CALIFORNIA COASTAL COMMISSION

**May 20, 2020**

Subject: Comments on Pacific Grove Shoreline Management Plan

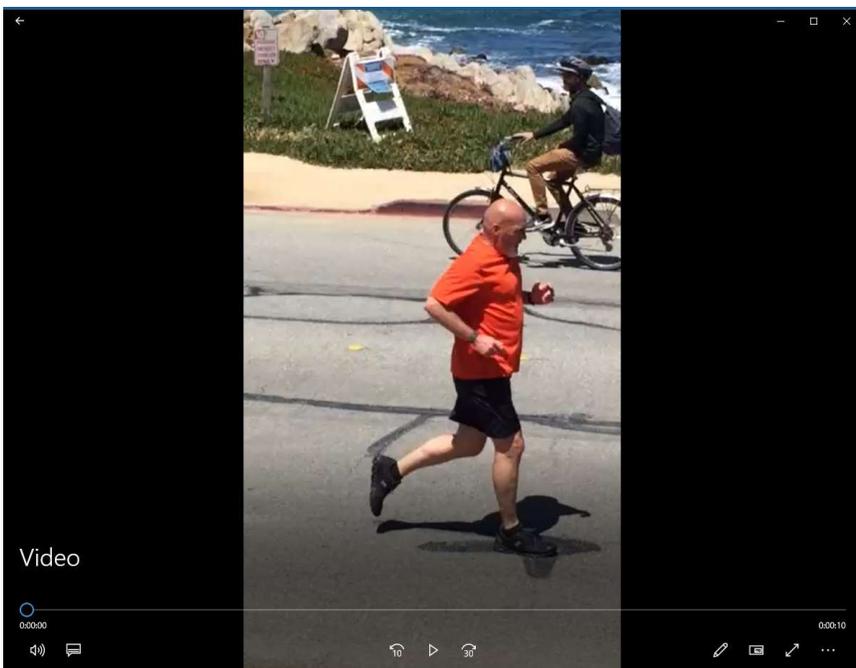
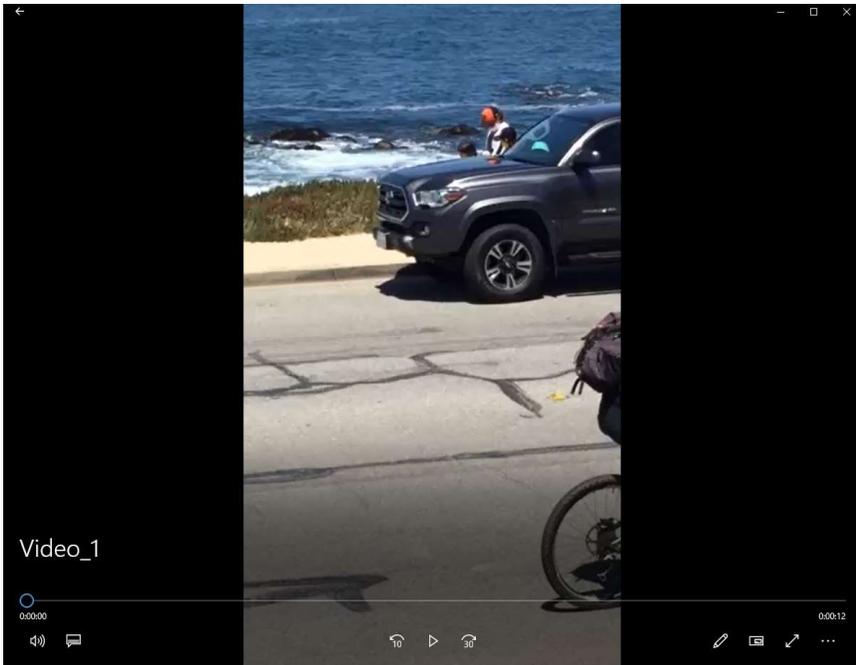
Attached are pictures/videos of the traffic situation/traffic hazards that pose a real and serious hazard to people using the trail, bicyclers, visitors, etc. A very hazardous condition that will only exacerbate the situation by reducing the width of Ocean View Blvd. by removing the curb and moving it out 6-7ft.
